From: [Hannah McLatchie](#)
To: [Chisholm, Brandon M.](#)
Cc: troy.reiss@inl.gov; steve.nesbit@lmt-consulting.com
Subject: NRC Initial Comments for TIMaSC White Paper
Date: Monday, December 22, 2025 11:28:00 AM
Attachments: TIMaSC_NRC Comments.pdf

The purpose of this email is to provide you with the NRC's initial comments on the document titled, "Technology Inclusive Management of Safety Case (TIMaSC): White Paper" (ADAMS Accession No. ML25239A009). The attached document with NRC comments will be discussed during the planned January 29, 2026, public meeting on this document. The meeting notice and agenda for this meeting will be issued shortly.

**Technology Inclusive Management of Safety Case (TIMaSC):
White Paper**

Document Number
SC-21256-100
Revision 0

Figure 2. Preliminary Notional High-Level TIMaSC Network Diagram

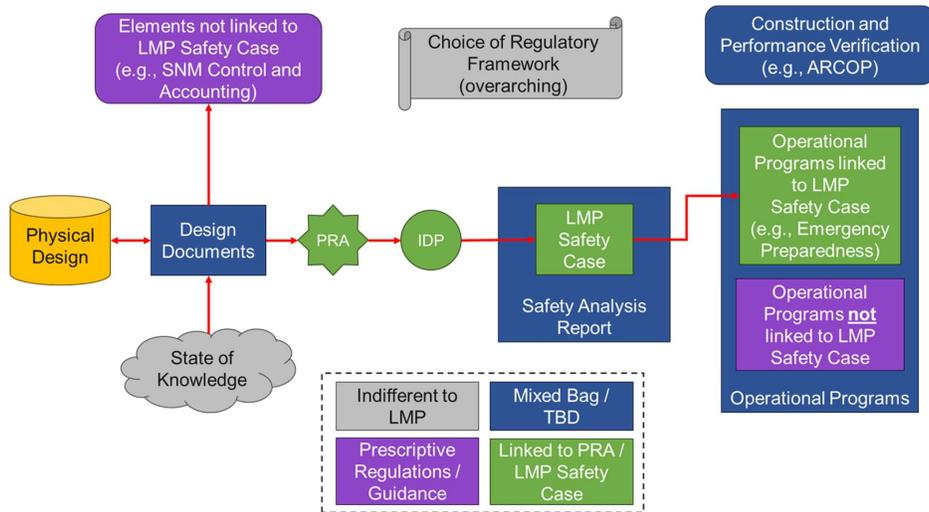
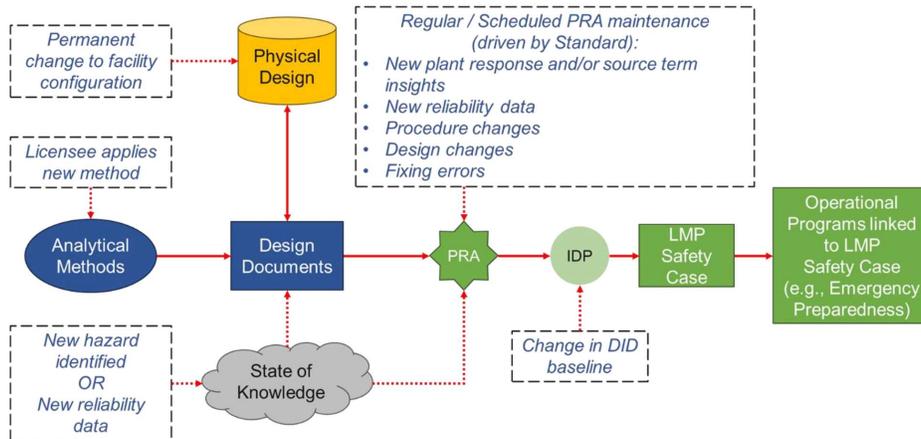
Commented [WR11]: Just an observation that linear nature of figures 2 and 3 may not reflect the discussion of an iterative approach taken for both initial plant design and development of operational programs and the subsequent changes to plant design and programs during operation. Consider a revision or discussion to reflect connections are iterative and include feedback loops (in some ways TIMaSC is a roadmap for those feedback loops).

Commented [WR12]: Consider revising or adding a new figure adapted from DiD figure 5-2 in NEI 18-04, which shows iterative and relational nature of design/analysis/operational programs. For example, Figure 3 has a box for LMP safety case that feeds operational programs which is probably more reflective of the traditional approach. Under LMP, the operational programs along with the design provide the safety case - which is best represented by the margins between LBEs and the F-C targets

Figure 4. Preliminary Modification of NEI 18-04 Figure 5-4 to Consider Propagation of Changes to RIPP Safety Case

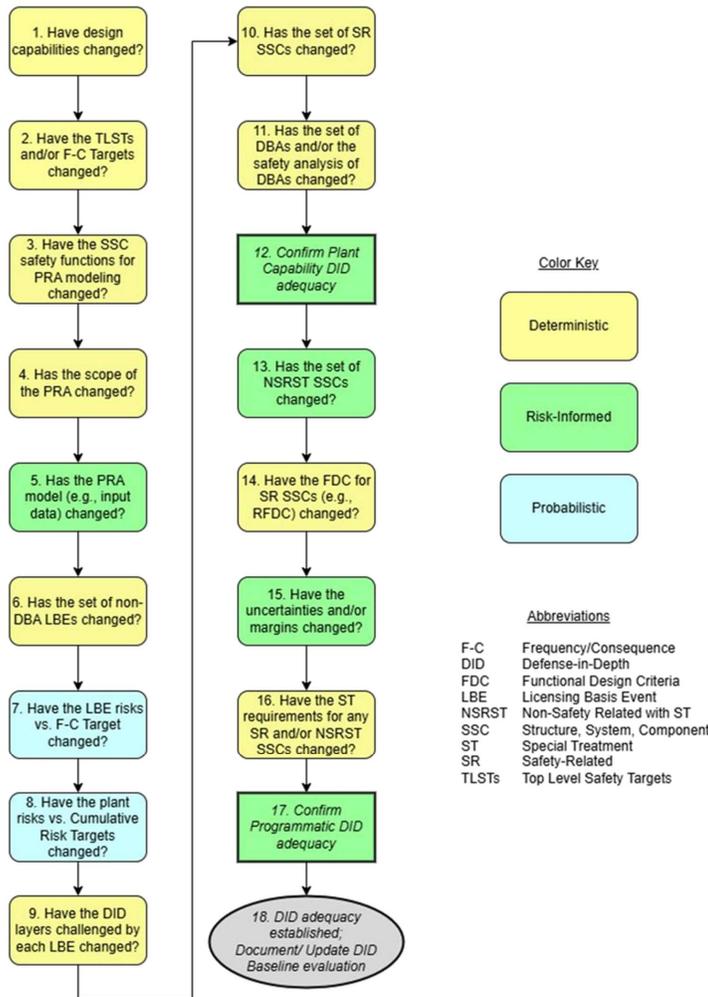
Commented [WR15]: Consider if TIMaSC is to be primarily a change evaluation process (as figure sort of indicates) or a broader assessment performance monitoring program (periodic reconciling of licensing basis to actual plant design/performance)- one element of which could be an actual plant change. This could then tie into what could be the hub of TIMaSC which is the configuration control of the PRA (including any supplementary analyses) - and getting input from RAP or maintenance rule program, design engineering, program owners, etc.. For example, one feeder could be the performance targets - if met: OK and no change to PRA or other key parts of the licensing basis, if not met: a corrective action needed and that could be a combination of revising analyses, programs or design. Much of figure 5 might still be there if desired to say how an item might show up in the licensing basis as presented in the FSAR but TIMaSC was thought to be a broader framework that is also addressing a level of supporting information below what is in the FSAR
